NOTICE OF ADDENDUM  
ADDENDUM NO. 1  
CONTRACT NO. 8504  
CEDAR STREET ASSESSMENT DISTRICT – 2021 & SOUTH STREET, HIGH STREET, AND WEST  
WINGRA DRIVE ASSESSMENT DISTRICT – 2021

Revise and amend the contract document(s) for the above project as stated in this addendum, otherwise, the original document shall remain in effect.

U-3

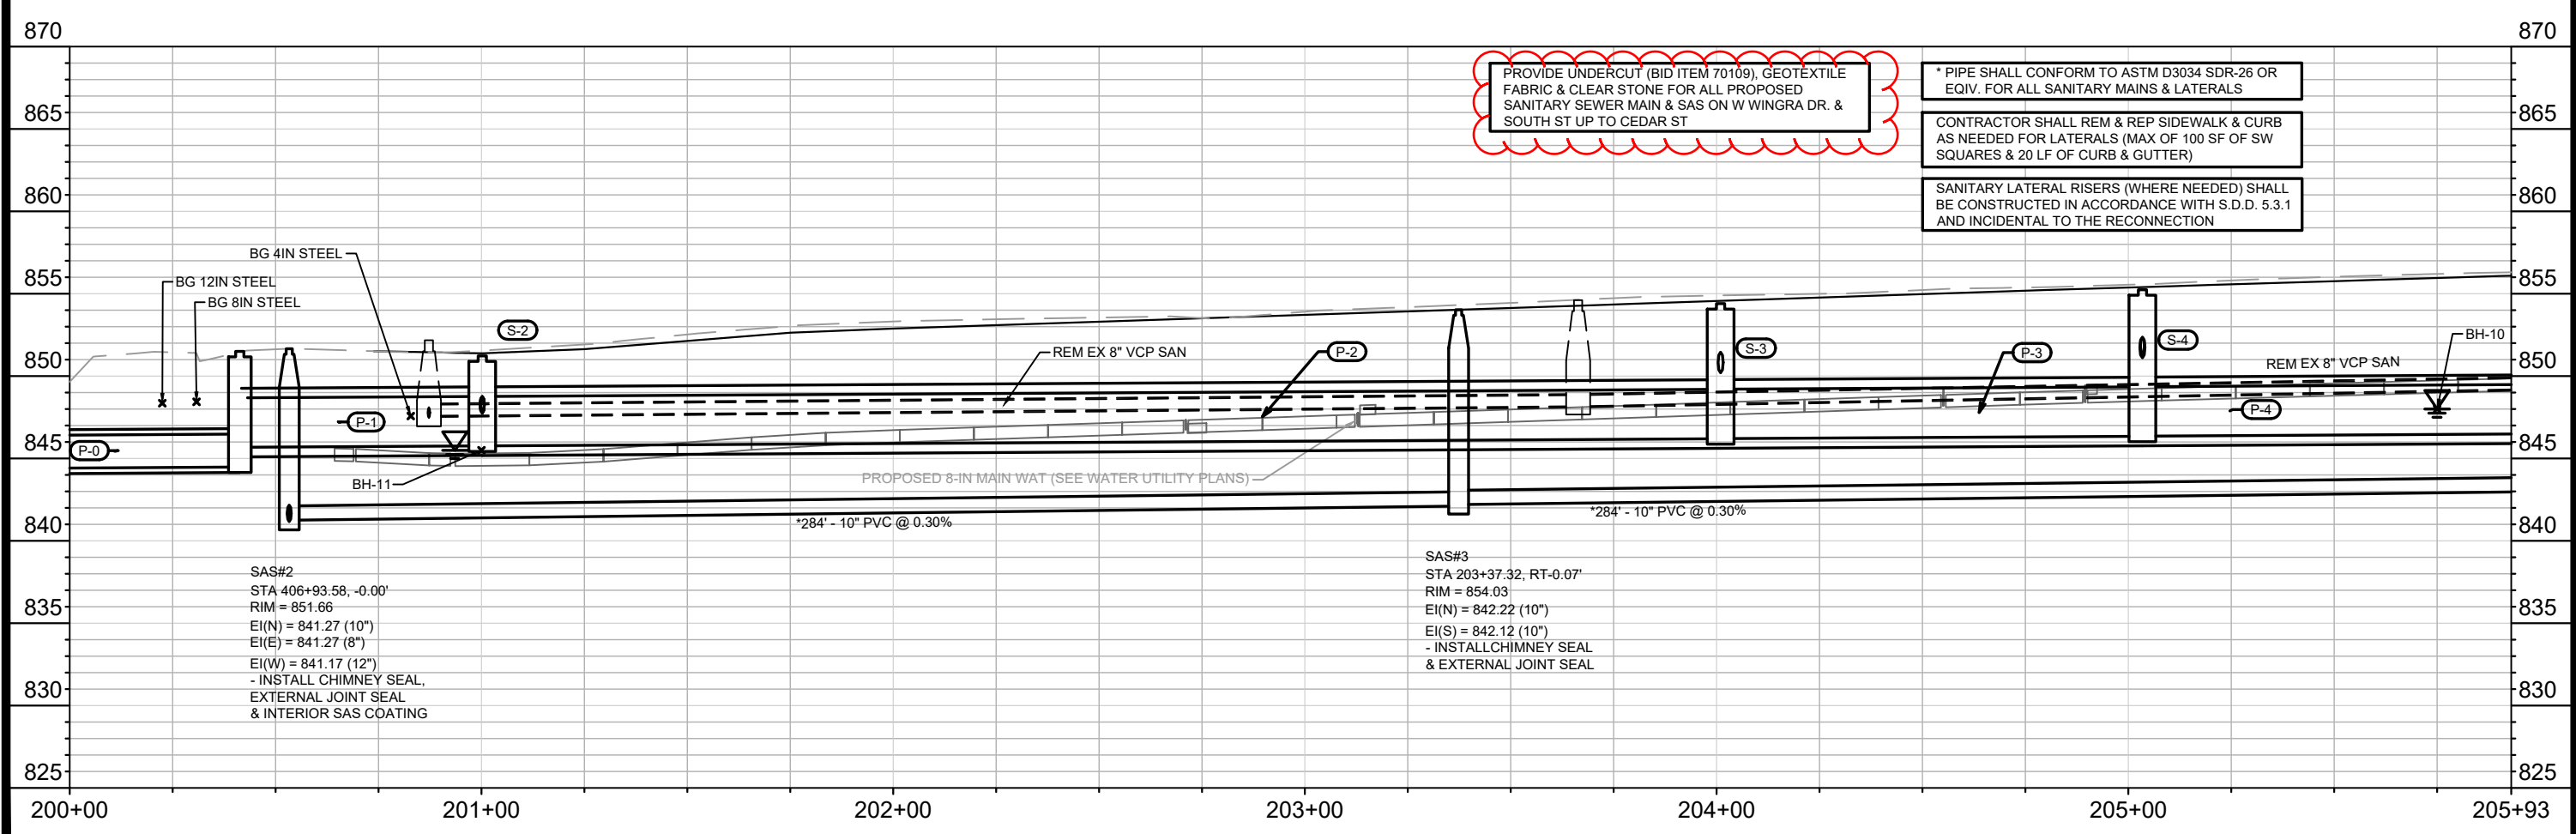
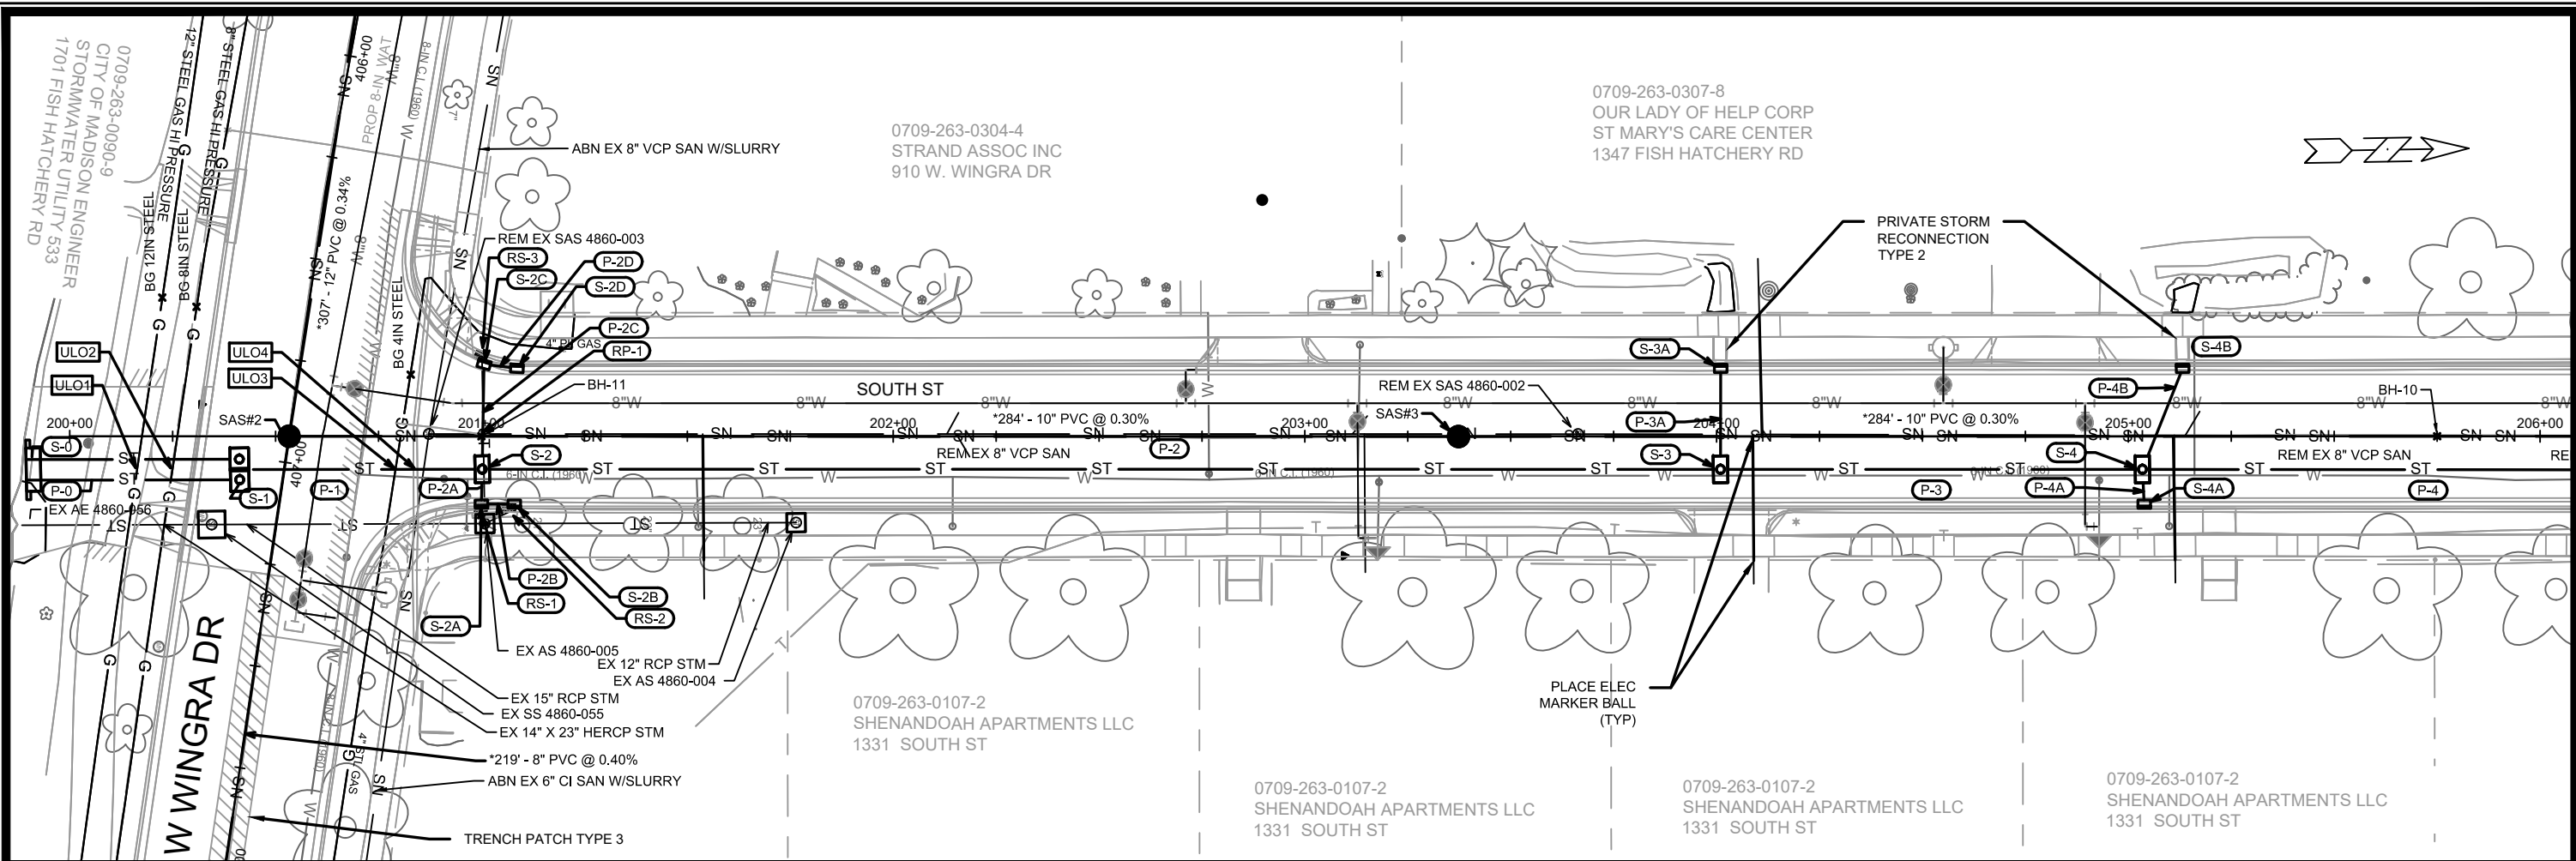
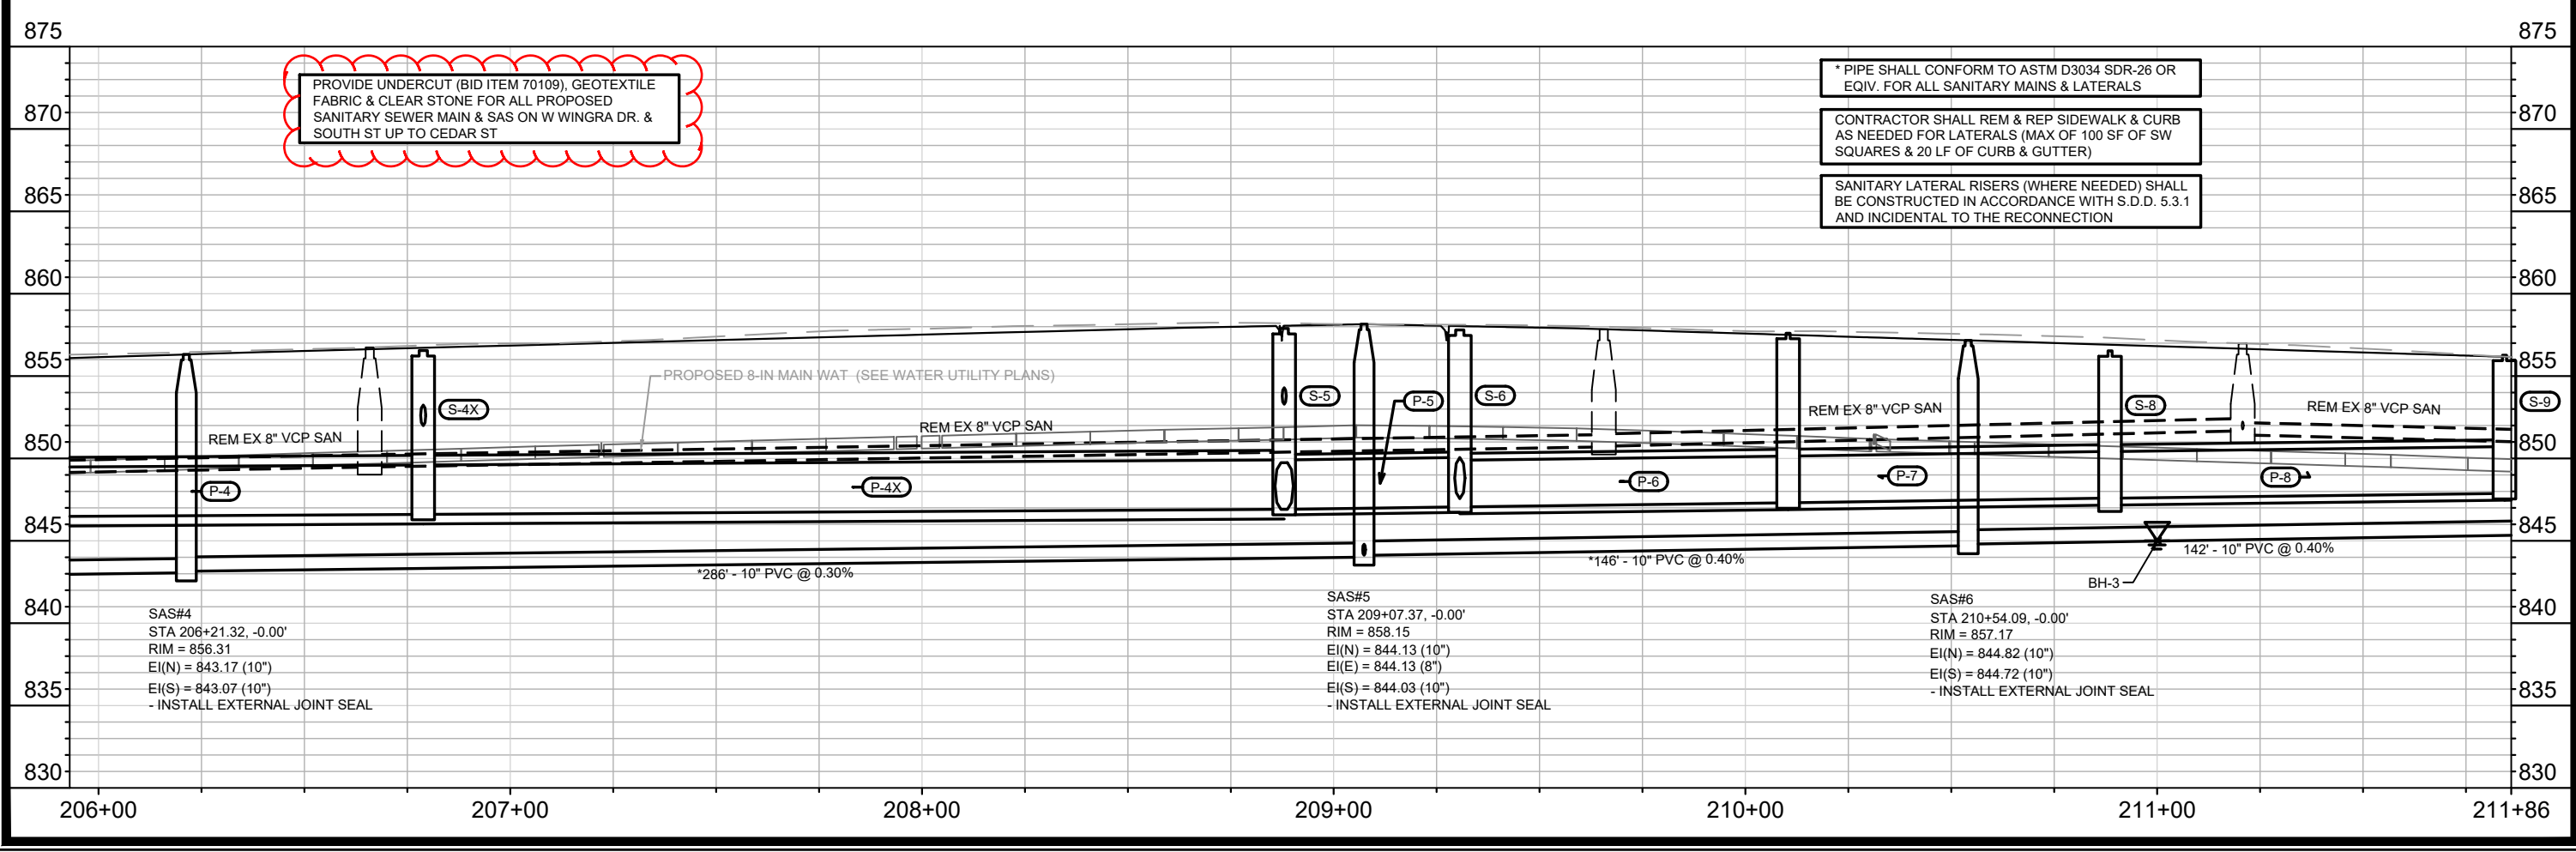
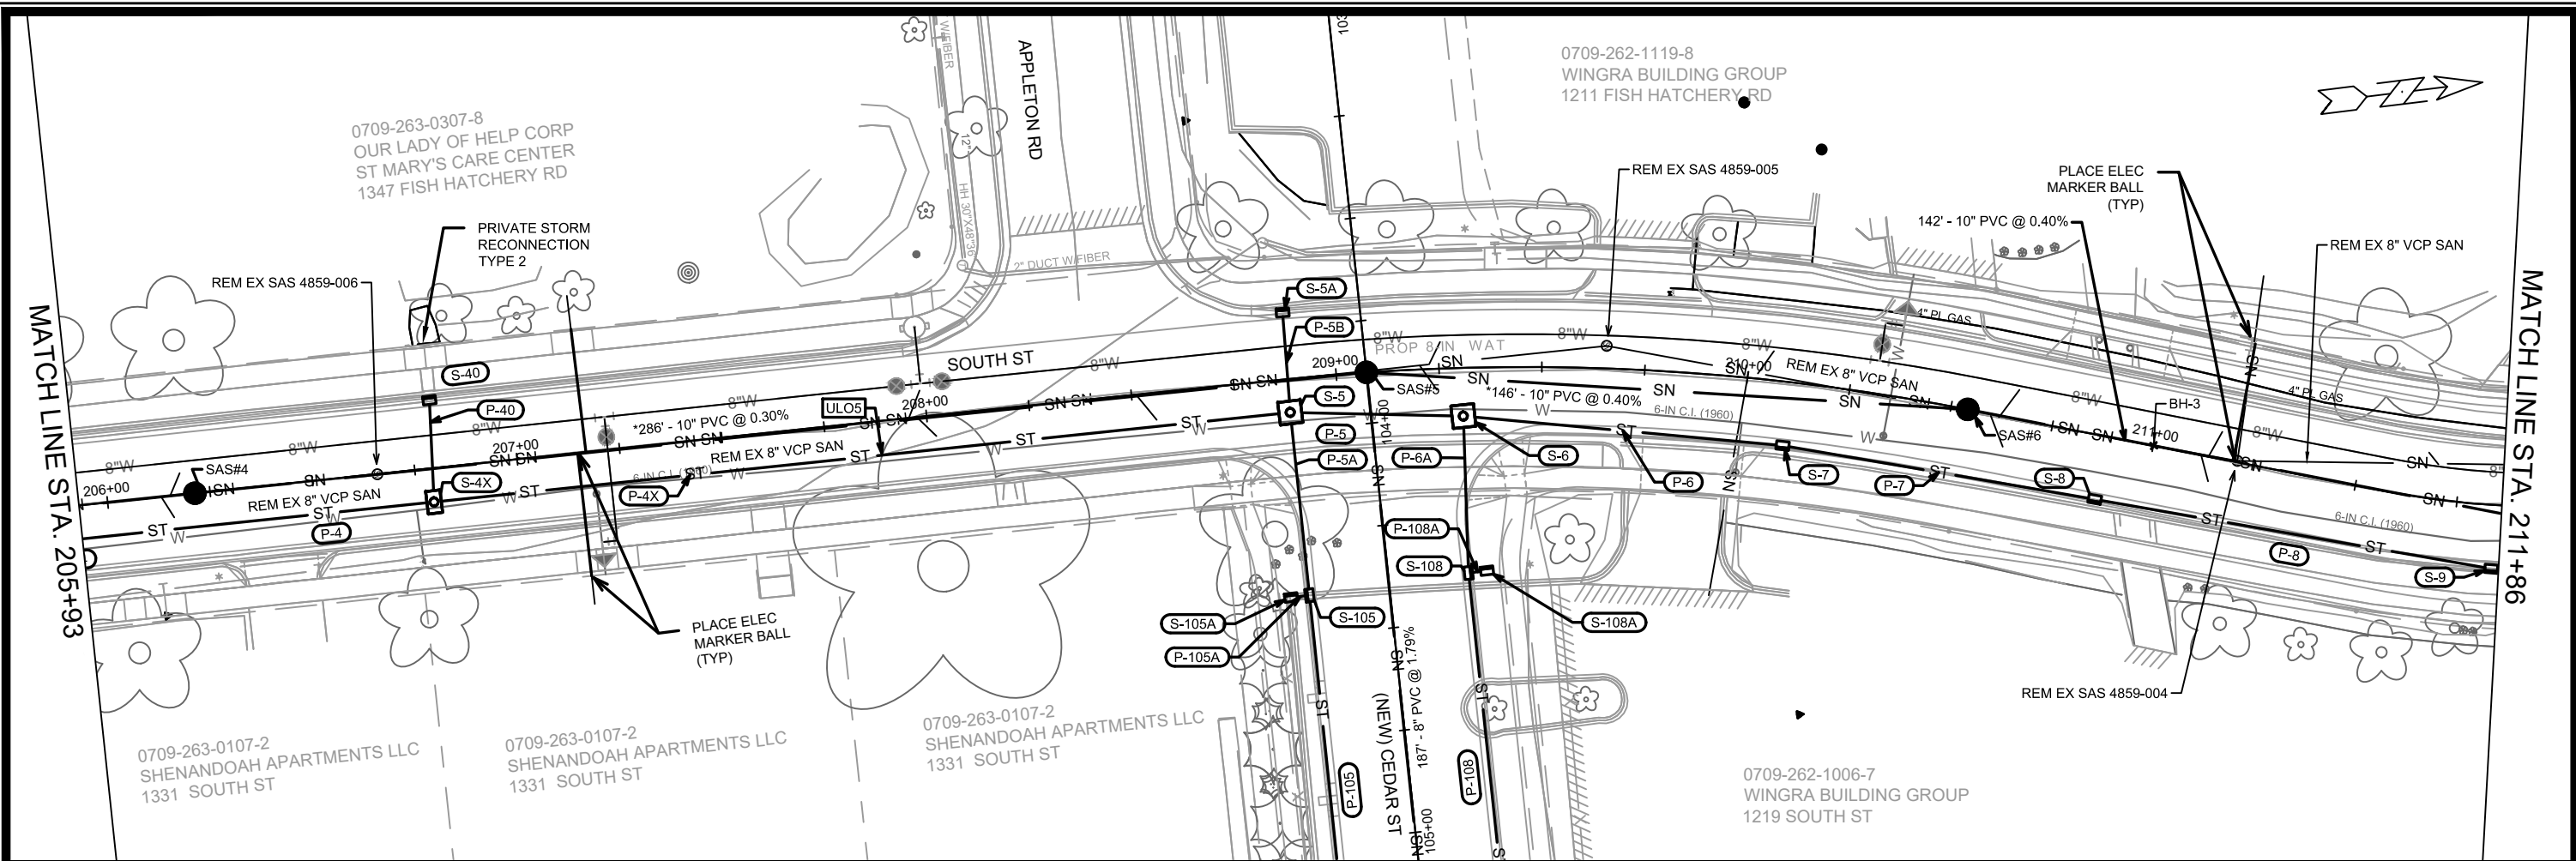
U-1 – U-8: Revised plans to updated undercut information.

PROVIDE UNDERCUT (BID ITEM 70109), GEOTEXTILE FABRIC & CLEAR STONE FOR ALL PROPOSED SANITARY SEWER MAIN & SAS ON W WINGRA DR. & SOUTH ST UP TO CEDAR ST
